# Energy

Proposed Code Modifications

**Sub Code: Building**

Total Mods for Energy: 107

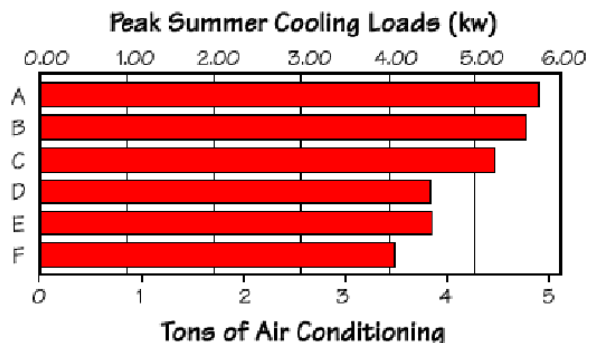
## Disapprove Modification 4320

Modification 4320 should be disapproved because it would take a substantial step backward in energy efficiency by completely removing protections against inefficient glazing in homes. RECA wholeheartedly supported the inclusion if the trade-off maximums in written and in-person comments during the drafting phase of the proposed code, and we continue to believe that this section is a crucial part of Florida's energy requirements. The glazing trade-off maximums currently found in Section 402.5 of the 2009 IECC and the draft 2010 Florida Building Code are simple mandatory measures that ensure that all new homes contain high-quality, cost-effective windows that save energy and block unwanted solar gain in warmer climates.

Every state that has adopted the 2004, 2006, and 2009 IECC has adopted these maximums without amendment. The maximums are seamlessly built into compliance software such as the Department of Energy's REScheck. The proponent of 4320 claims that the requirement is "difficult to explain and confuses most code users who often misinterpret it," but these simple, necessary backstops for trade-off programs are successfully being applied by builders and code officials in more than half the United States. The maximums have been repeatedly challenged over the last 10 years in the ICC process – and repeatedly upheld. Although the IECC Code Development Committee narrowly approved a proposal that would eliminate the maximums in 2012, that proposal must still go before the nation's building officials in October, 2/3 of whom voted in favor of keeping the window caps in the 2009 IECC.

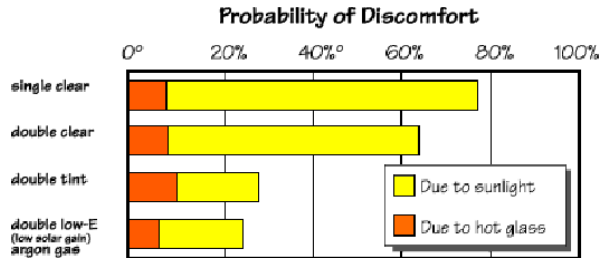
The chart below, again produced by LBNL and displayed on the EWC website, shows the probability of discomfort during summer from sunlight and hot glass. The potential comfort problem from bad windows is even worse in the summer. The summertime probability of discomfort ranges from almost 80% with single clear and over 60% with double clear declining to almost 20% with windows as specified by Section 402.6.

In cooling-dominated climates, windows with low SHGC will protect against hot spots and occupant discomfort, and will make it less likely that occupants will need to adjust the thermostat and use more energy.
